RE: Legacy at Journal Center

Grading and Drainage Master Plan

Engineer's Stamp Date 6/7/17 Hydrology File: D17D106

Enclosed is a revision of the Legacy @ Journal Center Overall Drainage Management Plan per the email correspondence dated 04/13/17 between BHI & COA in regards to the basin area changes and discharge into Lang Ave.

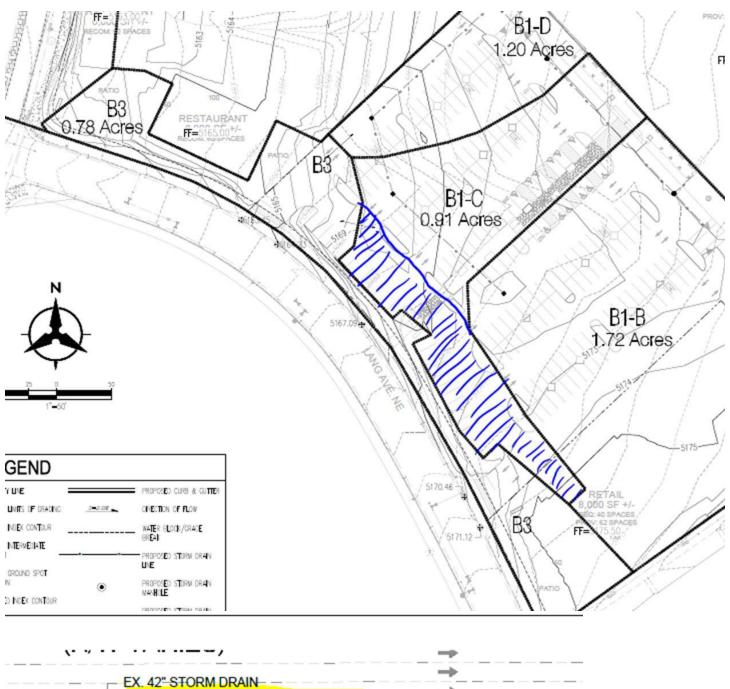
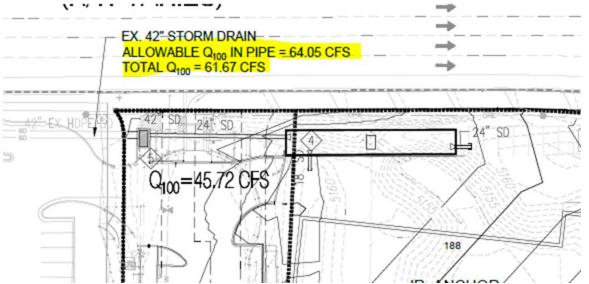
Good afternoon Shahab and Dana, during construction the owner noticed that the change in elevation between the existing Roadway (Lang) and the edge of a portion of the Cabela's parking have approximately 3' of grade difference between the two (See attached exhibit). The reason we had originally done this was to maximize the amount of drainage heading to the existing NMDOT inlet. The markups noted in green are existing and the markups in red are what we are proposing. Looking over the basins, this would increase basin B3 which drains directly to Lang and ultimately to the new NMDOT Median drop inlet currently under construction. The increase is approximately 14,100SF resulting in approximately 1.5CFS. We know that the inlet we are installing with the Headline improvements has enough capacity and the pipe has enough available (See highlighted inlet below) so we are wondering if this could be done in the field and noted on the asbuilts for the Cabela's drainage cert due to the fact they will be paving any day now. Let me know your thoughts as soon as possible please. Thank you!

You can go ahead with the field changes. Please make sure you submit all the supporting calculations at the time of asbuilt submittals. You do not need a submittal at this time.
